From: Damian Maguire
Sent: Wednesday 29 September 2021 17:50
To: Jonathon Edgeworth; Sinéad Carey
Cc: John Joyce; Louise Best; Seamus Ryan
Subject: RE: [EXTERNAL] RE: BRDS GDD Connection 1A

See below comments in red where minor changes have occurred since our last review. Remaining text appears to be as previously agreed.

GDD Connection 1A to the BRDS 9C

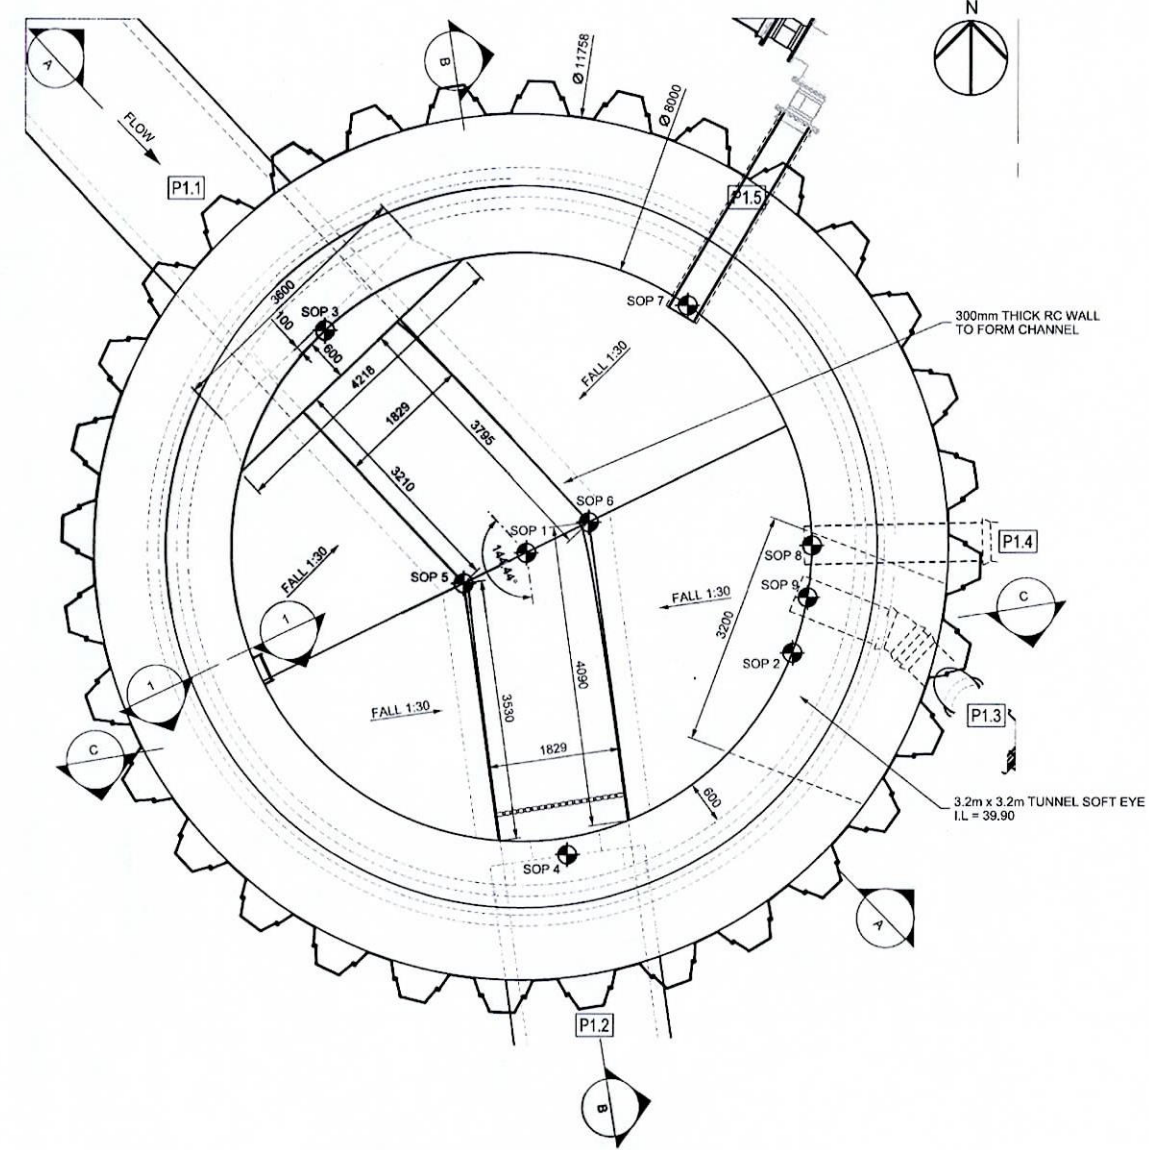
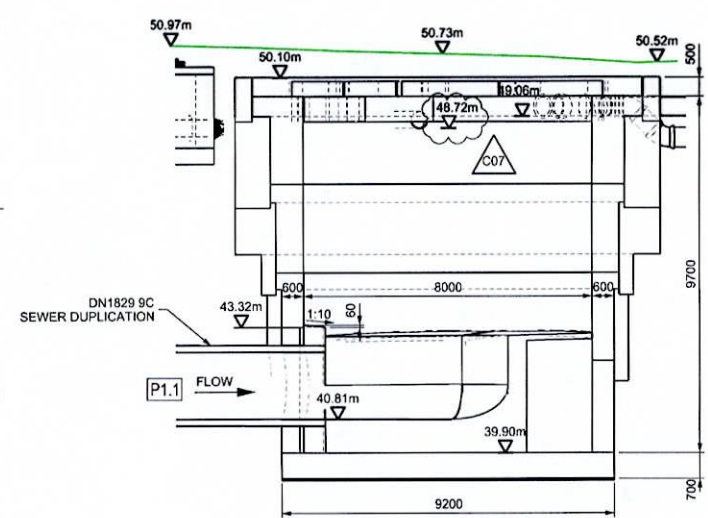
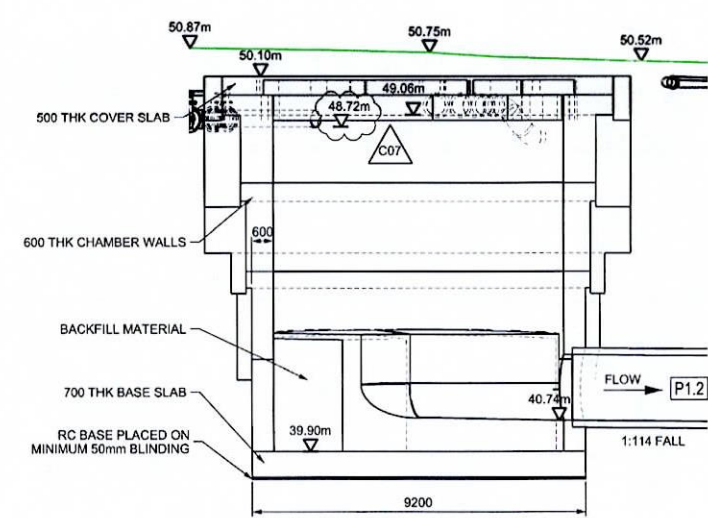
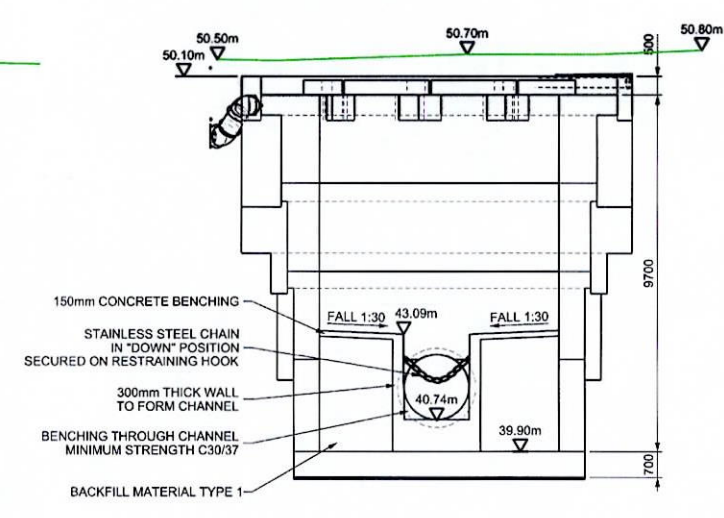
- The soft eye dimensions are 3.2m x 3.2m from a level of 40.1mOD to 43.3mOD; *IL of 39.90mOD on the soft eye. ie from a level of 39.90mOD to 43.10mOD*

- The invert level of the connection point is 40.75mOD; Invert level of the channel is 40.74mOD.
- The co-ordinates for connection are X =708106.256 Y = 738926.931; Co-Ordinates for the centre of the chamber are 708102.5145E, 738928.3445N
